SECTION 53 COMMENTS NATIONAL GRID RESPONSE

Project	Waikanae North Development
Application reference	FTAA-2603-1194
Site	169-171 Peka Peka Road, Waikanae, Kapiti Coast
Document	Response to comments received under section 53, Fast-track Approvals Act 2024 National Grid
Prepared by	Joseph Harris, Landlink Ltd Ray O'Callaghan, O'Callaghan Design Ltd
Date	10 August 2026
Status	Final

JOB	STAGE	SHEET	REV
2911-	P0-	100	-A

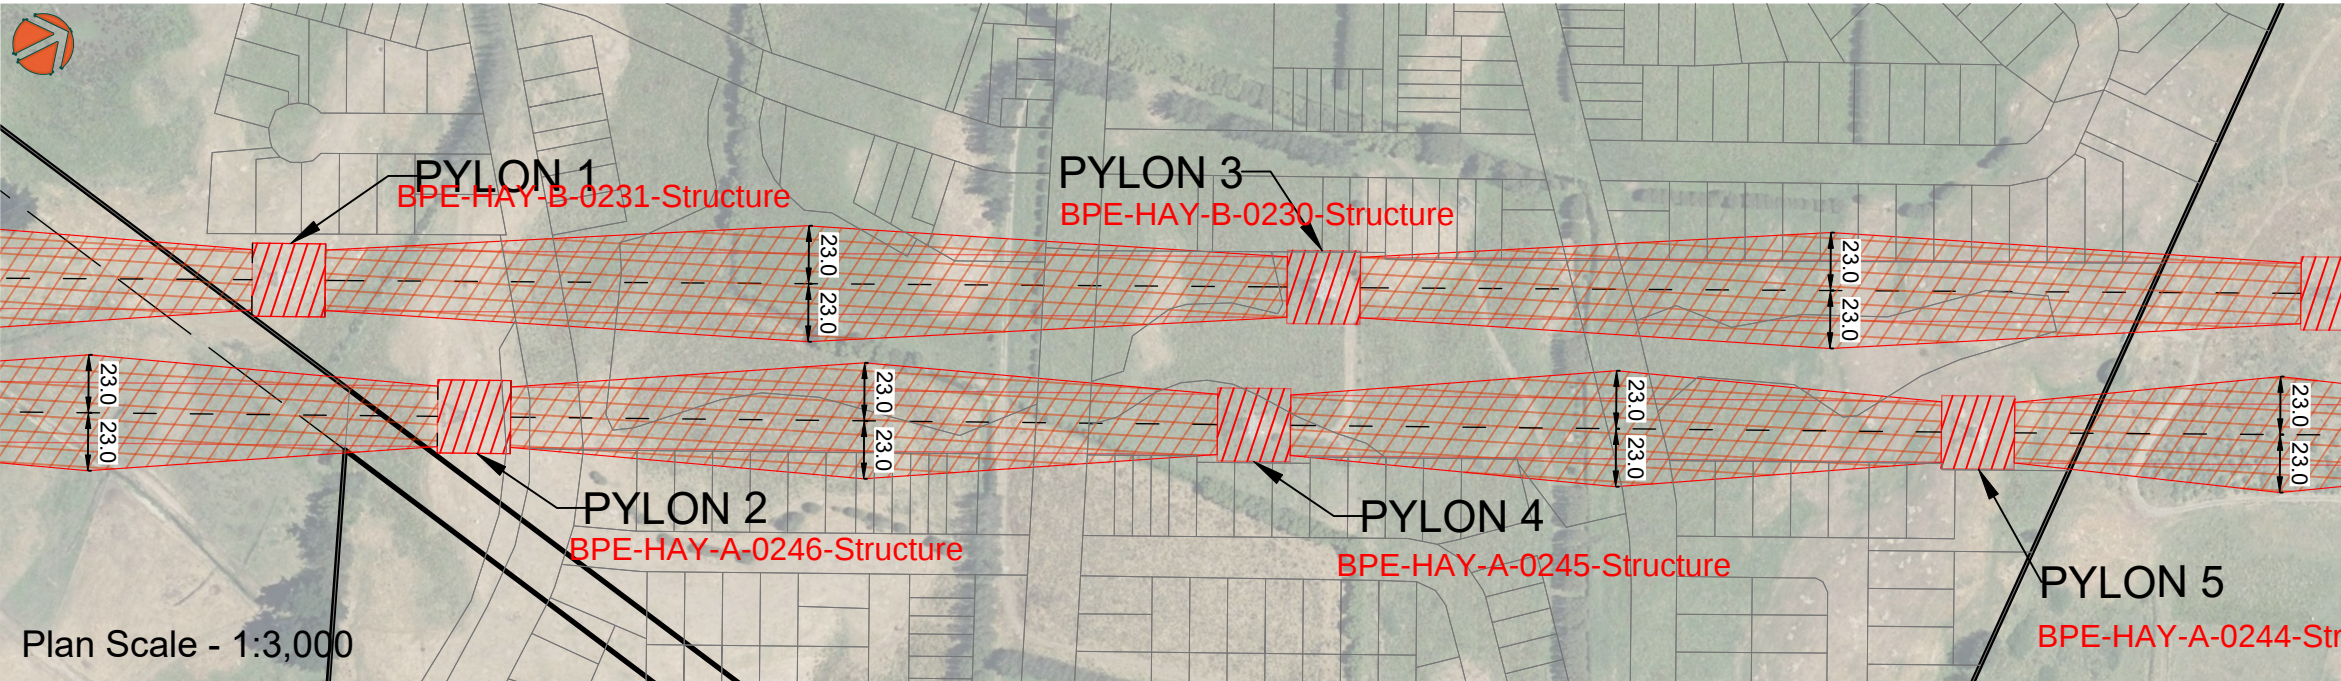
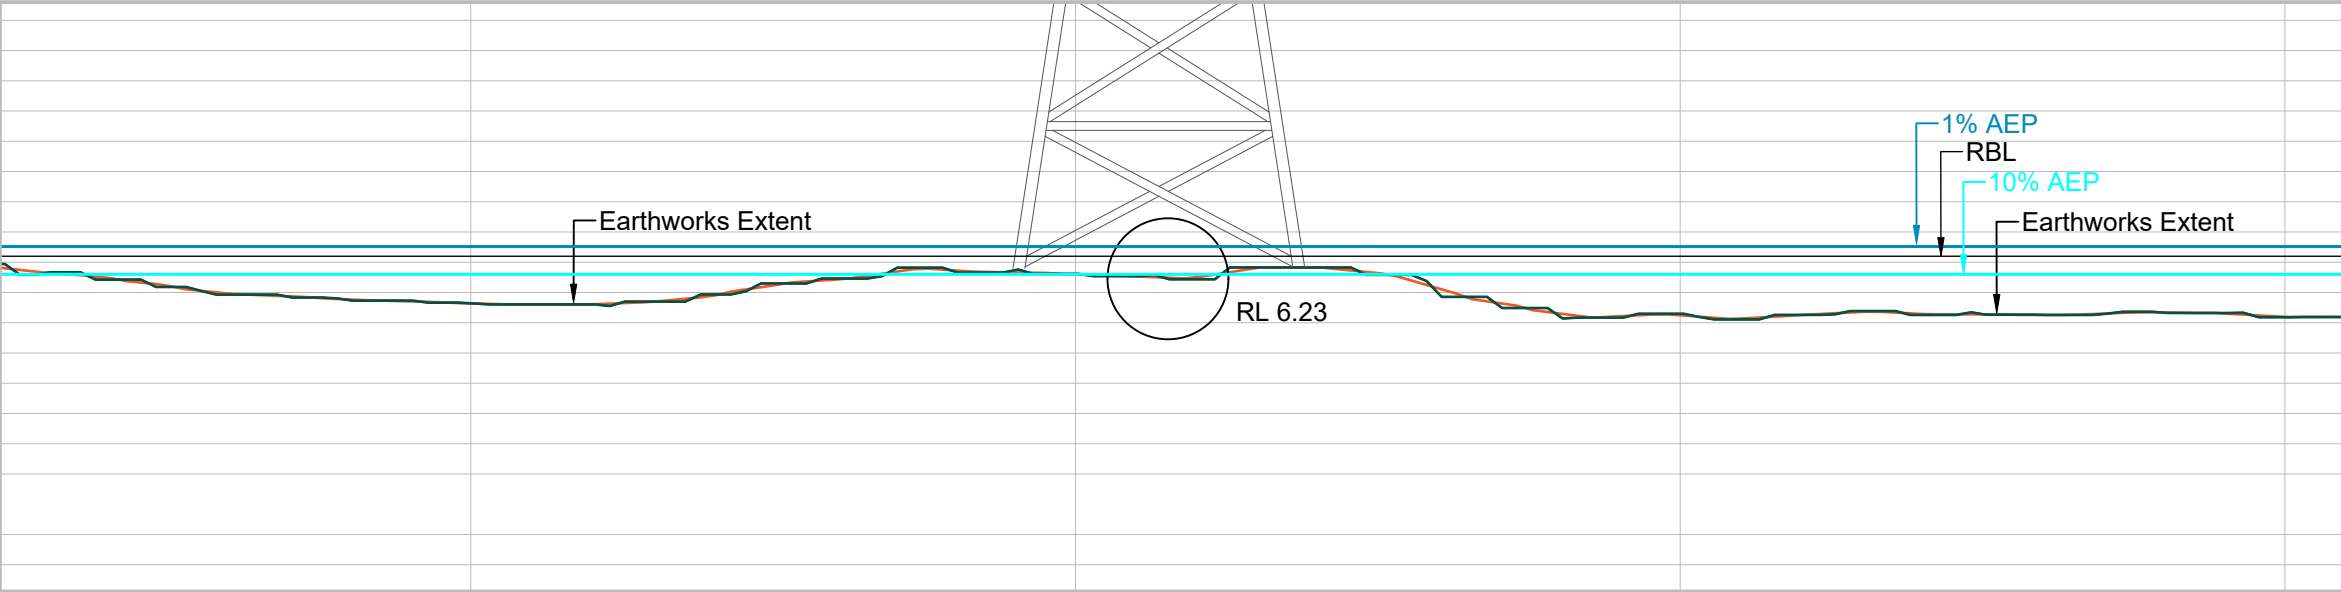
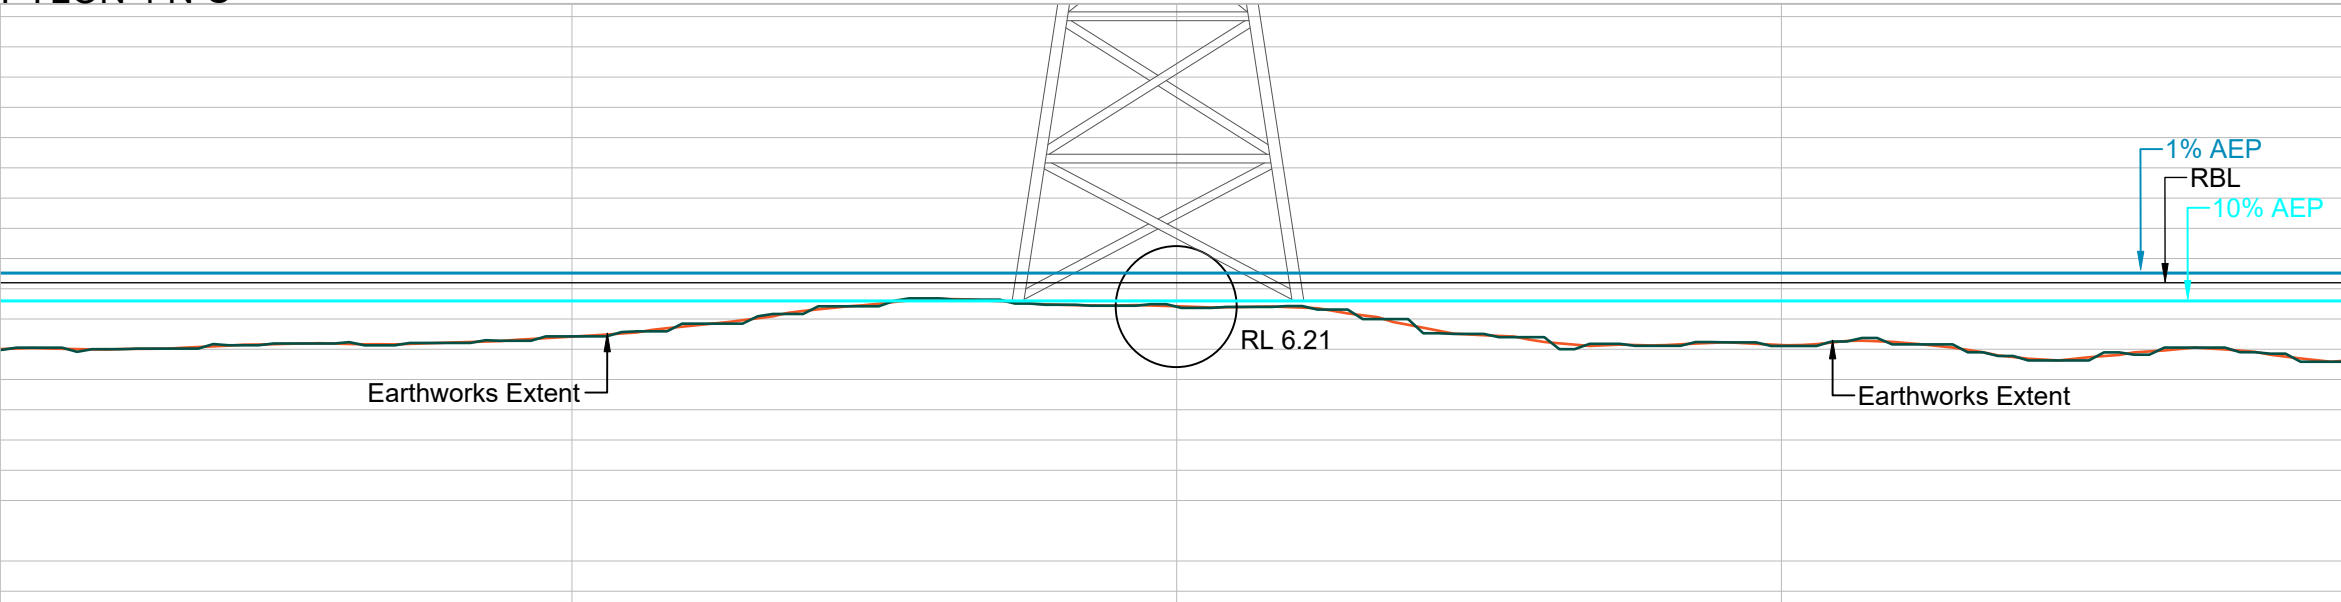
Comment. "Transpower requests the NGY Corridor is clearly shown on all scheme plans and "Transpower requests the plan referred to in the corresponding consent Conditions (regional consent condition 140 and land use consent condition 12) is prepared and forms part of the Substantive Application." (paras 4.2–4.3)

Response. The National Grid Yard (12 m either side of centerline, 12 m from support structures) and the 23 m blowout envelope are shown together on the Transmission Corridor Constraints Plan 2911-P0-100-Rev A (**attached** to this response for convenience), that has previously been provided to Transpower. This plan has been subsequently amended to Rev B to include additional flood level information that has been requested, Rev B is also **attached** to this response. The amended Rev B plan can be referenced directly in Conditions 140(d)/12(d). This meets the request.

JOB STAGE SHEET REV
2911- P0-100 -B

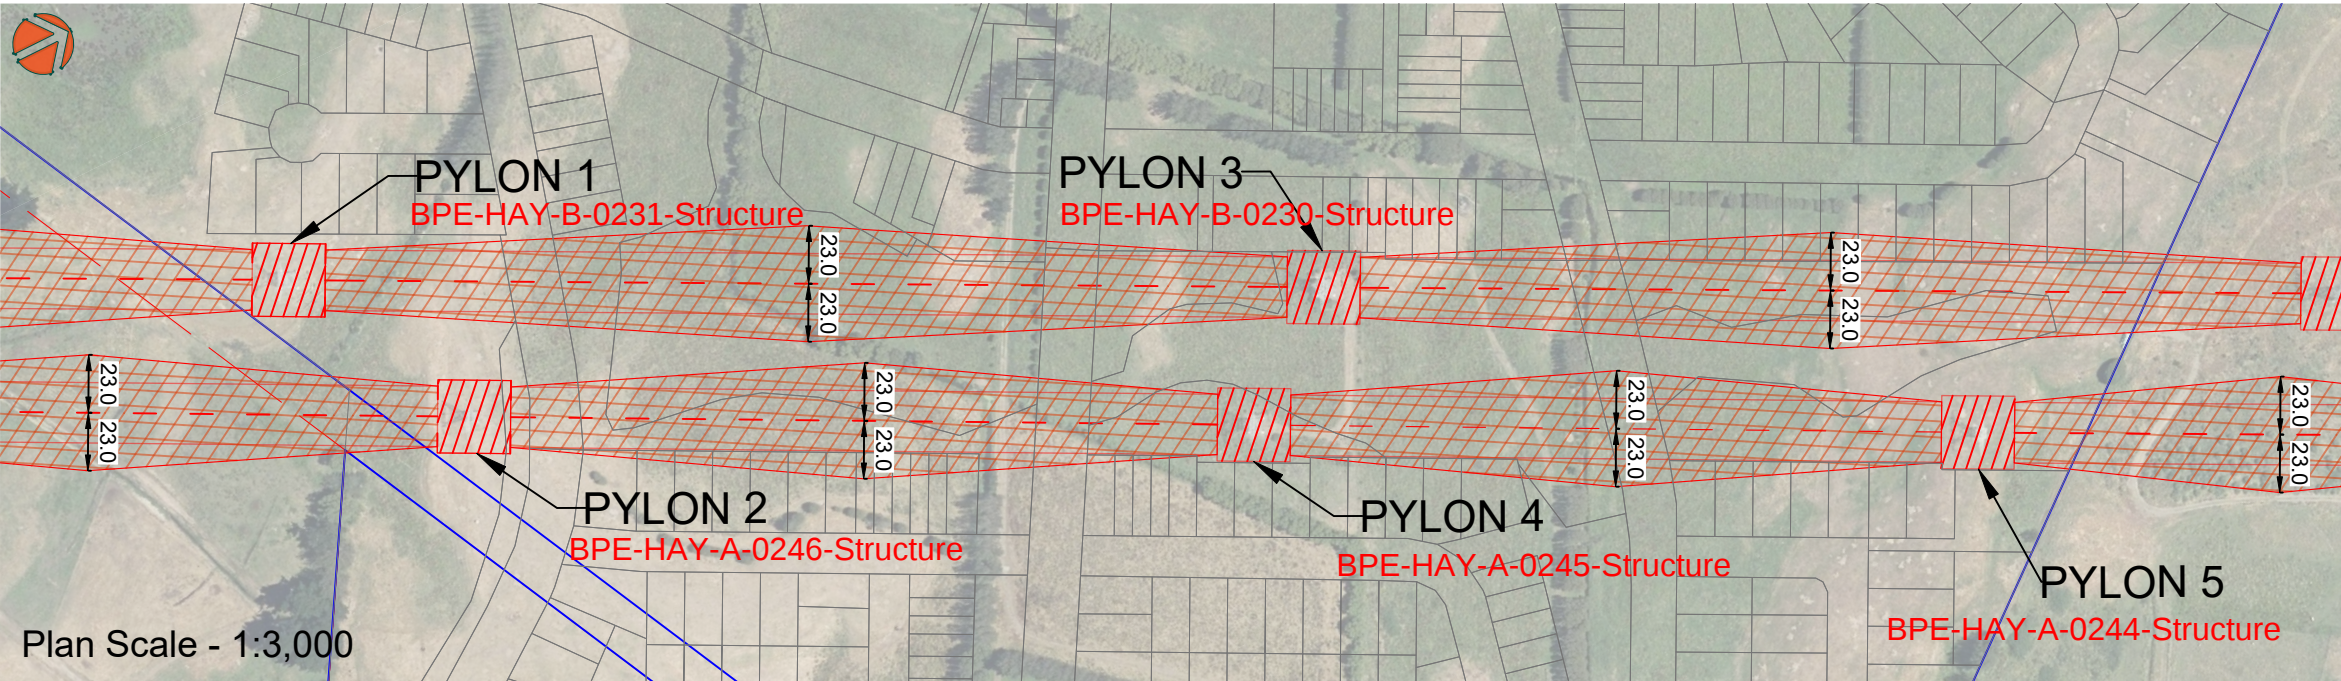
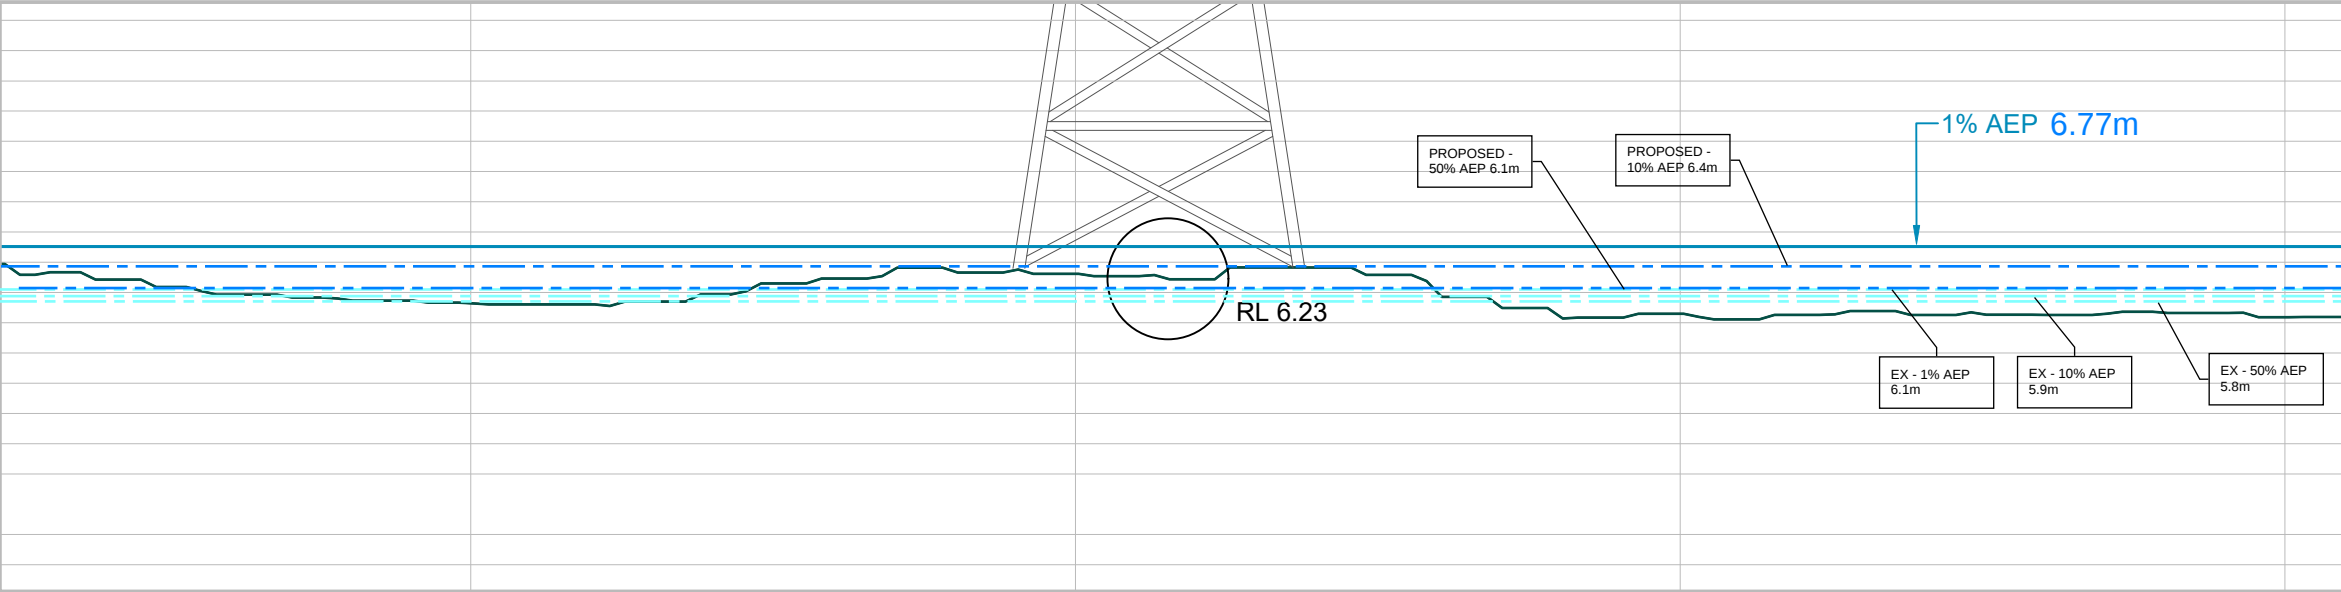
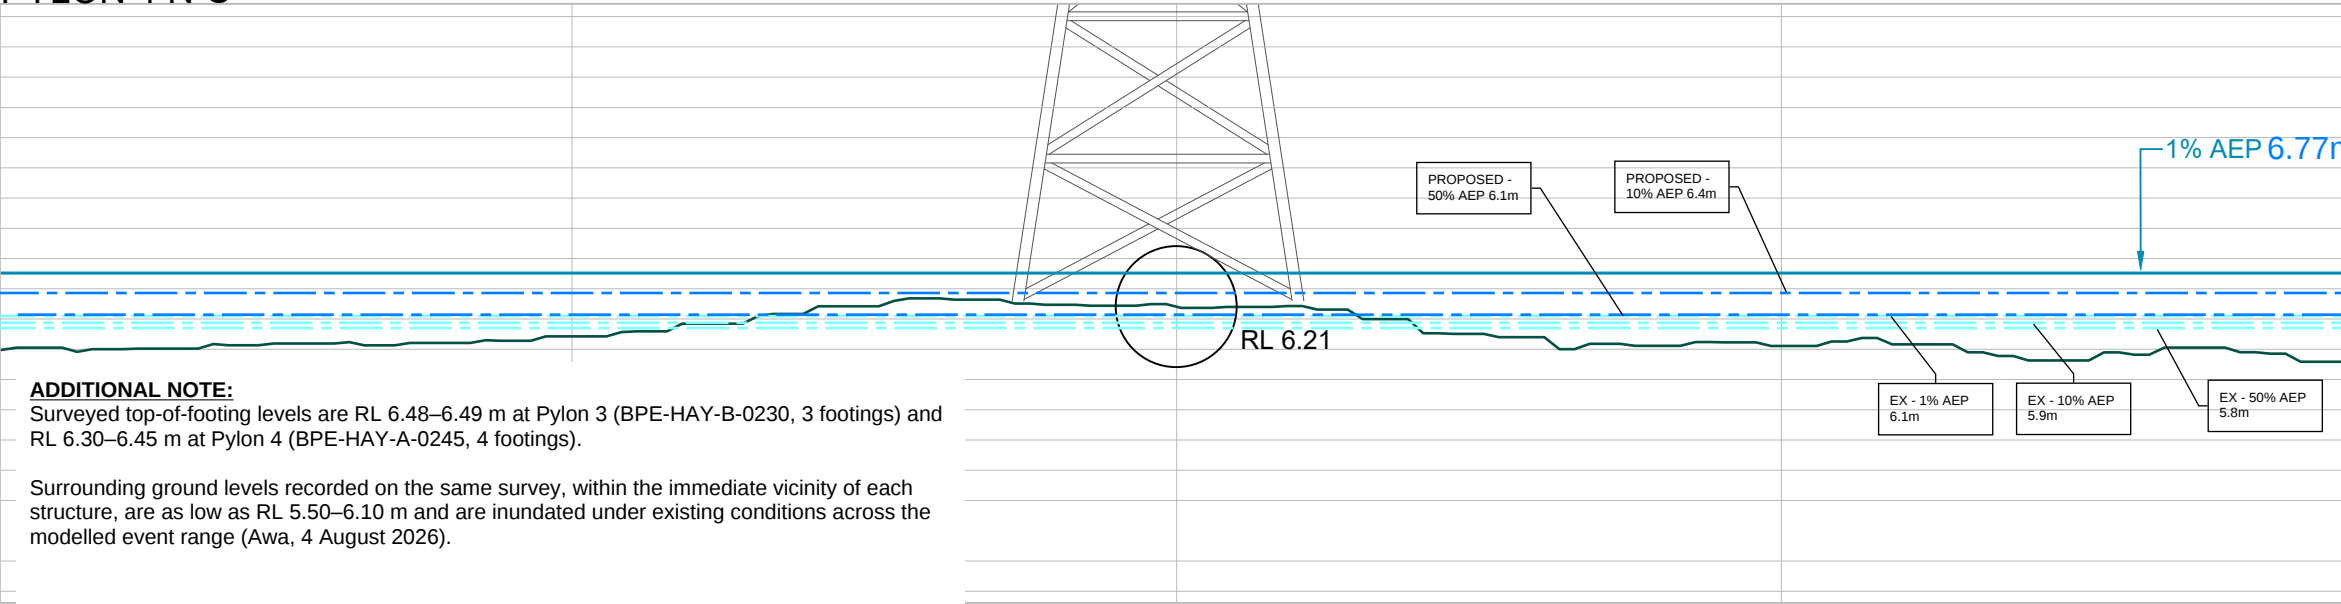
Comment. "Transpower is concerned about the potential effects of the proposed development on the foundations of National Grid support structures... In particular, there is potential for increased flooding around support structure foundations, which could adversely affect their long-term structural integrity. These potential effects have not been adequately assessed in the Substantive Application."

"Transpower requests that the Applicant provide a site-specific assessment of the effects of the proposed development on floodwater levels and ponding around National Grid support structures BPE-HAY-A0244, BPE-HAY-A0245, BPE-HAY-A0246, BPE-HAY-B0230, and BPE-HAY-B0231. This assessment should quantify any change in floodwater depth, extent, duration, and frequency at each support structure location." (paras 4.12–4.15)

The table above includes the expected flood water levels for the other events. These results are also shown in drawings 2911-PO-100, 055 & 056-Rev B (attached).

Under the design scenario, modelled peak levels exceed all recorded footing levels at both structures for the 50YR and 100YR events, and exceed three of Pylon 4's four top of footing levels (RL 6.30–6.39 m) at the 10YR event; the design therefore increases the existing ponding to reach the footings directly in the larger events.
